Interactive comment on “CABra: a novel large-sample dataset for Brazilian catchments” by André Almagro et al.

Response to Editor – Alberto Guadagnini

Response to reviewers Referee #1 - Pedro Luiz Borges Chaffe

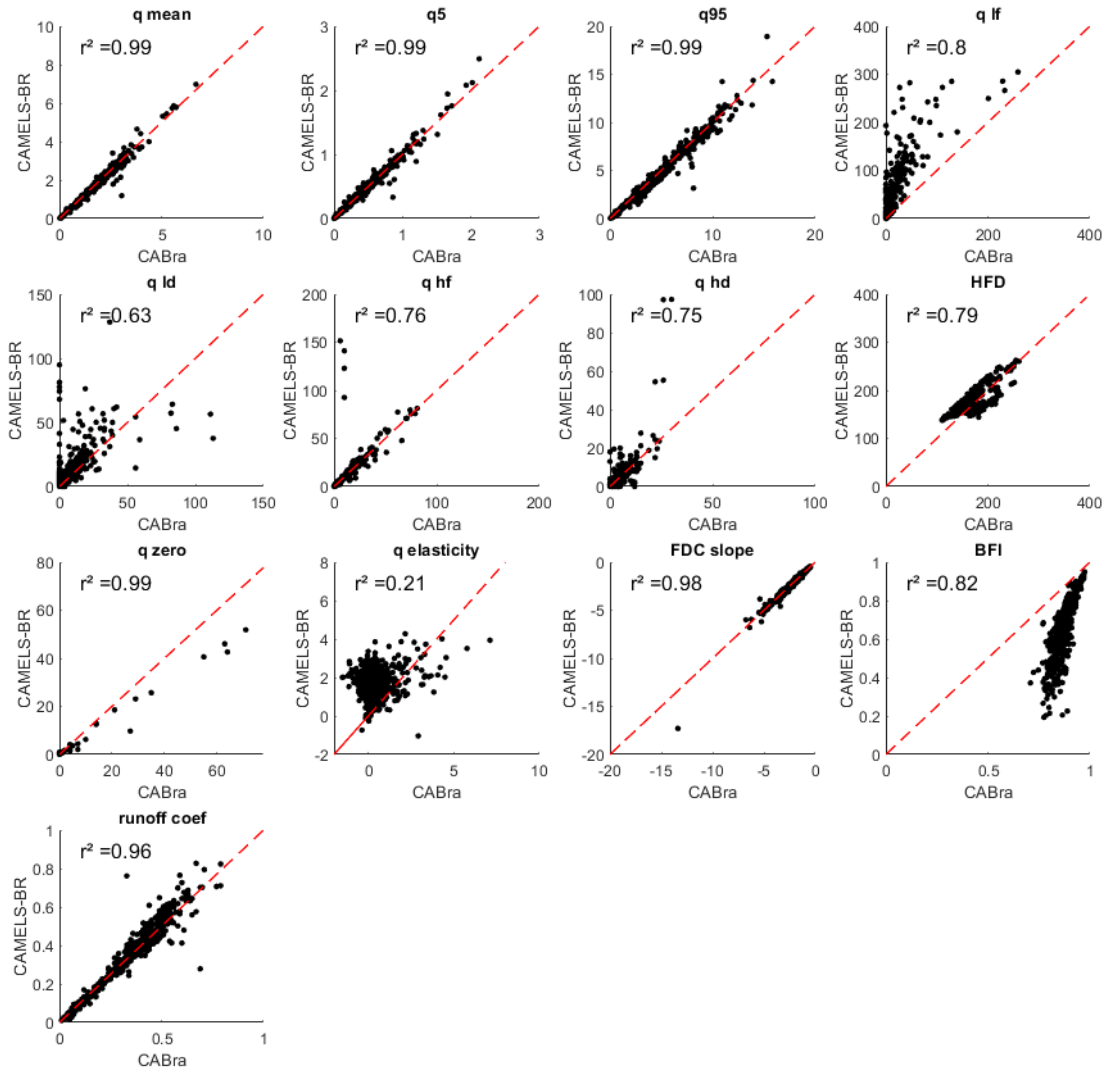
Comment #2: As major comments, I believe the authors could highlight those new products they produced and the novelty of the manuscript by: (1) framing CABra as a complementary dataset that builds on some opportunities left by the CAMELS-BR dataset (e.g., need for drainage density and uncertainty analysis); (2) making use of the CAMELS-BR for a quantitative comparison to show if or how the different approaches and data sources might influence signature values. I would also create a new section after the Introduction called “2 Motivation to extend the CAMELS-BR data set” similarly to Addor et al. (2017). This new section would be a more concise and accurate (see minor comments) replacement of section “3 Comparison with the CAMELS-BR. . .” of the current manuscript.

Author’s response #2: We appreciate your comments. (1) This dataset design and construction started a way before the publication of the CAMELS-BR dataset as seen in the first public presentation of the CABra dataset, in Oliveira et al. (2020). So, it was not “built on opportunities left by the CAMELS-BR dataset”. As most of catchment attributes datasets worldwide, CABra and CAMELS-BR present some overlapping attributes,

(2) Thanks for suggesting this analysis. We have performed (see Fig. R1) a simple but effective analysis to verify in which hydrological signatures and how the different approaches may impact more. We performed a correlation test in 607 corresponding catchments in both datasets. As can be seen in the figure, the signatures based only in daily streamflow values, such as daily mean streamflow (q_{mean}), 5th and 95th quantiles of daily streamflow (q_5 and q_{95}), are quite similar between CABra and CAMELS-BR, showing that both periods of analysis were capable to capture the streamflow patterns of the catchments. When comparing signatures related to frequency and duration of low and high streamflow events, we can note little variation but still good agreement between datasets. In this case, the distinct period for hydrological signatures calculation (1980-2010 in CABra, and 1990-2009 in CAMELS-BR) might be the cause of deviations. The slope of flow duration curve and runoff coefficient are in a very good agreement ($r^2 > 0.95$), demonstrating that both datasets are using precipitation products with good reliability. The streamflow elasticity and baseflow index have presented notable differences between CABra and CAMELS-BR. This might be due to the different components adopted in the equations of Woods (2009) and Ladson et al. (2013), which were implemented for elasticity and baseflow index calculations. This discussion can be found at L805-816 of the track change revised manuscript.

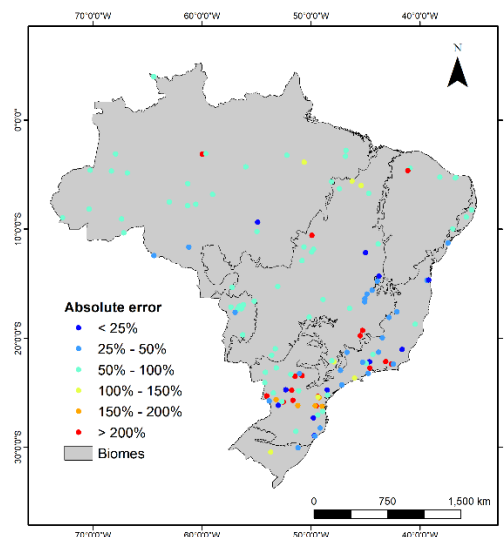
Comment #7: L67-72 – If this paragraph corresponds to Fig.1, should it read "hydrologic disturbance" or "Hydrologic signature"?

Author's response #7: "Hydrologic disturbance" is the correct, once we are describing the attribute classes of CABra dataset, but we agree that the information is not well-presented in the actual form of the paragraph. For the revised version, we have modified the figure to better explain the study design (L74 of track change revised manuscript).

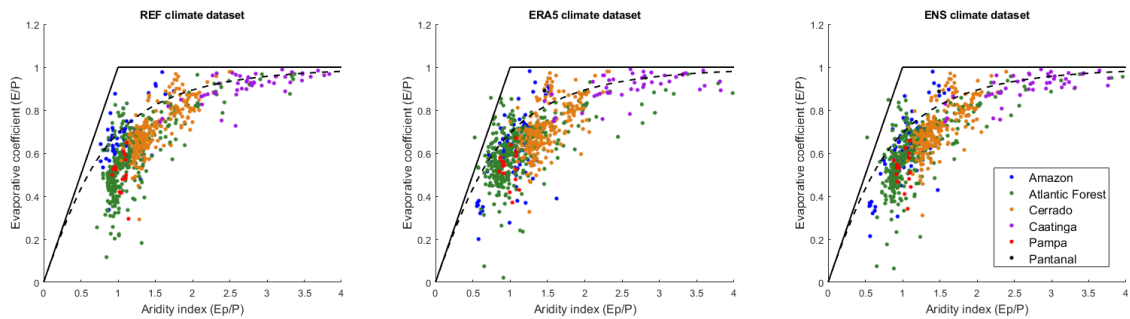
Comment #10: L118-121 – This is not accurate. Do et al. (2018) and Gudmundsson et al. (2018) methodology was based on the areas provided in ANA's dataset (the same you used to check the error). Even though they probably did not visually inspect the

boundaries for all the basins they provided, in the CAMELS-BR every boundary from the Do et al. (2018) data set was visually inspected (this procedure may not be explicit in Chagas et al., 2020). Please, check those references.

Author's response #10: Thanks for the information! We agree that Do et al. (2018) probably was not visually inspected due to the large number of basins worldwide. We only state that CAMELS-BR were not manually inspected because in Chagas et al. (2020) authors says "The main limitation of the procedure of Do et al. (2018) is that catchment boundaries were not manually inspected" and any information indicating that this limitation has been improved is presented to the reader, suggesting that the limitation persists in CAMELS-BR. Anyway, we corrected the information by removing the CAMELS-BR of the citation of non-checked datasets (L116-121 of track change revised manuscript).

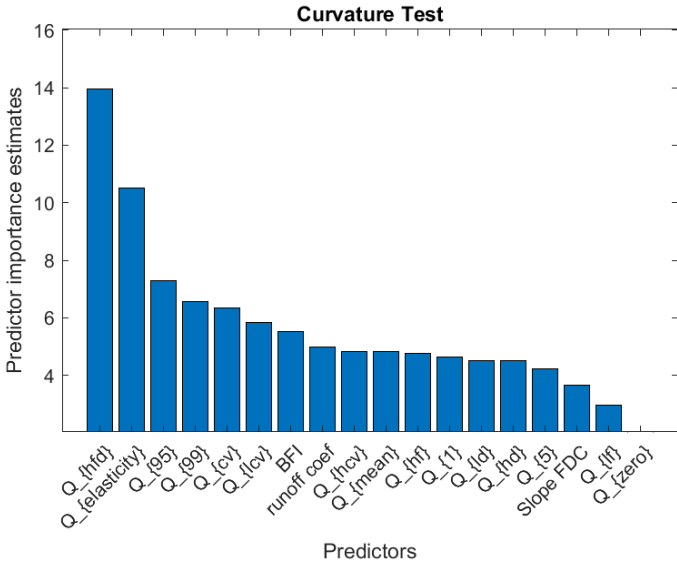
Comment #32: L539-540 – What is the data source for the reservoirs? The ANA (2017) reference was not provided in the reference list. In the CAMELS-BR the reservoir data from ANA (2018) and GRaND (Lehner et al., 2011) were combined and further checked against Pekel et al. (2016) in order to exclude very small (insignificant) reservoirs.

Author's response #32: Thanks for noting. It is true that the reference for the reservoirs' source is missing. We will provide it on the revised version. To clarify, in our database, we have used the National Water Mass Reference Database v2019, available at: <https://metadados.snirh.gov.br/geonetwork/srv/eng/catalog.search#/metadata/7d054e5a-8cc9-403c-9f1a-085fd933610c>. This database was prepared for generating information to support actions for planning, managing, and regulating water resources in Brazil, as described in ANA (2020b).

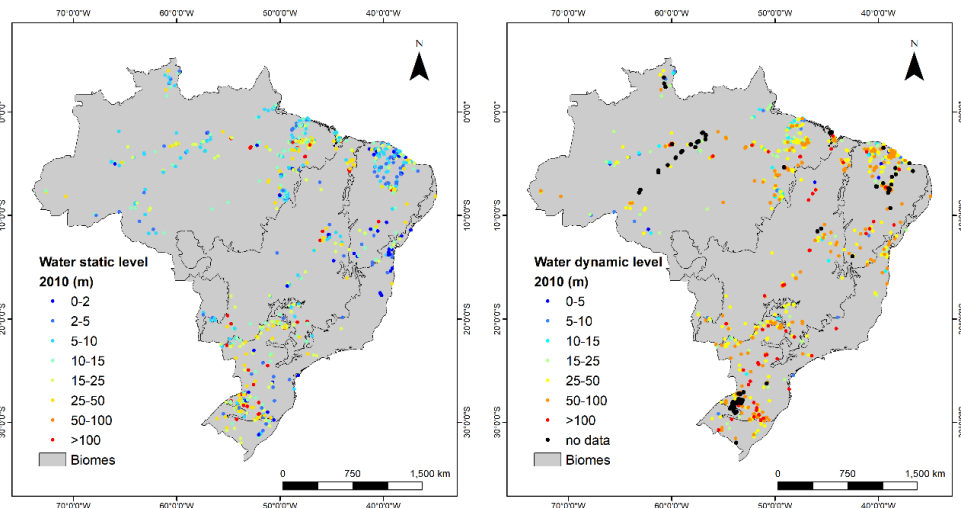
Comment #3: 2) For groundwater attribute: spatial variation of groundwater table is subject to complicated driving factors. Fan et al.'s (2013) can be useful for a regional scale analysis for pattern recognition but would have a lot of uncertainties at catchment scale. The observed well observation dataset would be more useful for such a large-sample catchment dataset effort.

Author's response #3: Thank you for your comment and suggestion. We will add to the dataset the static and dynamic levels observed in 2010, which is the last year from the daily timeseries of climate and streamflow in CABra dataset (Figure R1). We have obtained the wells observations at the Geological Survey of Brazil – CPRM database for groundwater, the Groundwater Information System – SIAGAS (<http://siagasweb.cprm.gov.br/>).
